World Forum for Harmonization of Vehicle Regulations

Proposal for Supplement 3 to the 01 series of amendments to UN Regulation No. 135 (Pole side impact)

Submitted by the Working Party on Passive Safety *

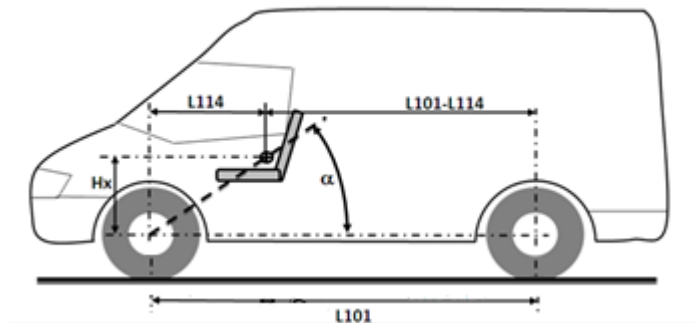
Paragraph 1.1. (b), amend to read:

- (a) Category M₁ vehicles with a gross vehicle mass of up to 3,500 kg; and
- (b) Category N₁ vehicles where, when positioned on a level surface with all tyres inflated as recommended by the vehicle manufacturer and the vehicle in unladen condition as defined in paragraph 2.24., the acute angle α , measured, between a horizontal plane passing through the centre of the front axle and an angular transverse plane passing through the centre of the front axle and the R-point of the driver's seat, as illustrated below, is less than 22.0 degrees; or the ratio between the distance from the driver's R-point to the centre of the rear axle (L101-L114) and the centre of the front axle and the driver's R-point (L114) is less than 1.30.²
